## 343 Forest Ave

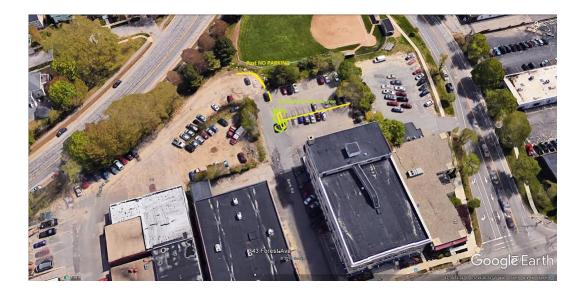
It would be good to better define Bank Street and the adjacent parking area, a small landscape island with a tree or two would is the preferred solution to define the parking lot from the right of way.

If this is problematic due to the loss of parking spaces pavement markings should be maintained and the gravel section of Bank Street could be posted for No Parking (the City PW Traffic group might do this since it is in the right of way)
